# EAST COLORADO SPECIFIC PLAN

Planning Commission Hearing September 22, 2021

## Planning Commission Study Session – August 25

### **Specific Plan Boundary**

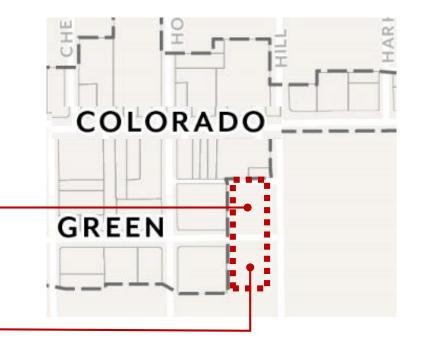
Interest in including the remaining parcels along E. Green Street between S. Holliston Avenue and S. Hill Avenue within the ECSP area

→ City-owned public facility

→ Institutional use regulated by CUP

- Any significant redevelopment proposal on these parcels would require zone change and/or CUP, including public review processes
- Recommendation to not include additional parcels in the plan area

### **Relationship to Adjacent Specific Plans**

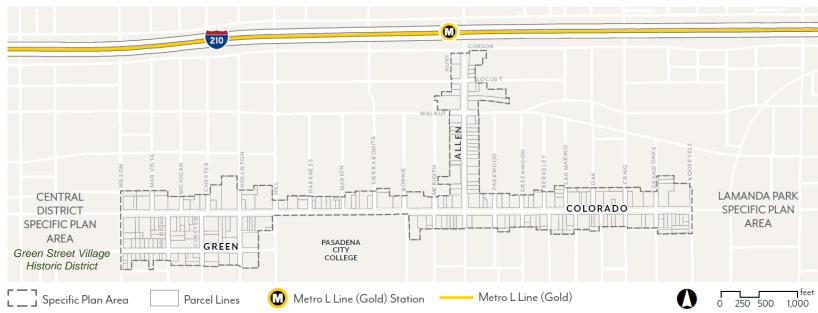
Reference relationships to the Central District and Lamanda Park Specific Plan areas

• Introductory text in Chapter 1 revised and references to adjacent specific plans added to Map 1.1-1

### **Building Heights**

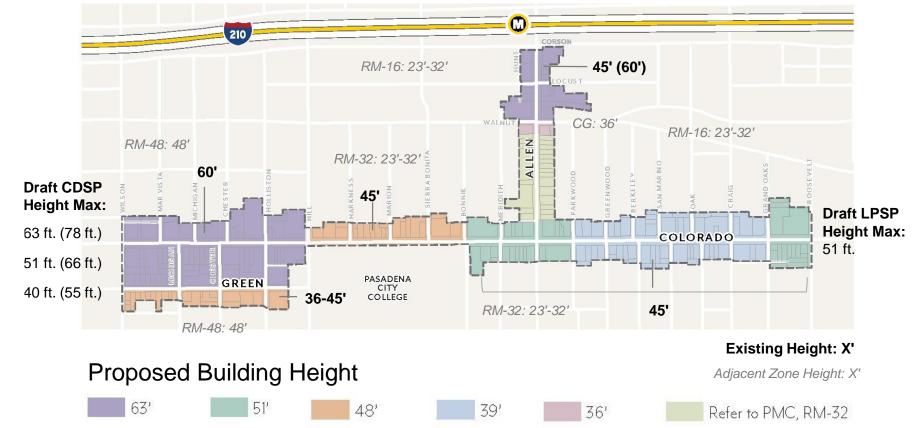
Request for information on potential height of future development when adding density bonus provisions

- Projects seeking Density Bonus typically receive an extra story
- Upper floor stepbacks still apply to DB projects

### **Publicly Accessible Open Space**

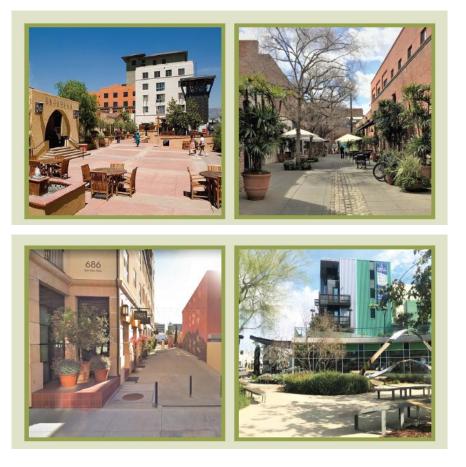
Concern with the use of the term 'public open space' to describe the requirement for private development to include open space that is accessible to the public

Replace term 'public open space' with 'publicly accessible open space' (PAOS) throughout proposed plan

### **Mid-City Green Connections**

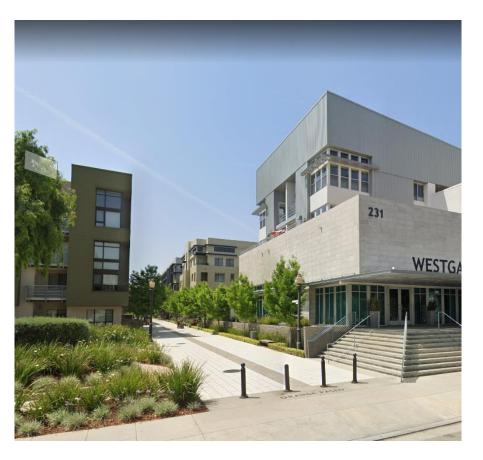
Interest in alternative tree species to supplement slow-growing oaks and create more near-term shade along Michigan and Chester

- In addition to the oak species designated by Master Street Tree Plan, recommend Fern Pines as faster growing alternative
- Fern Pine and oaks complement one another, support aesthetic and sustainability objectives
- Consideration for Urban Forestry and community when amending Master Street Tree Plan in the future
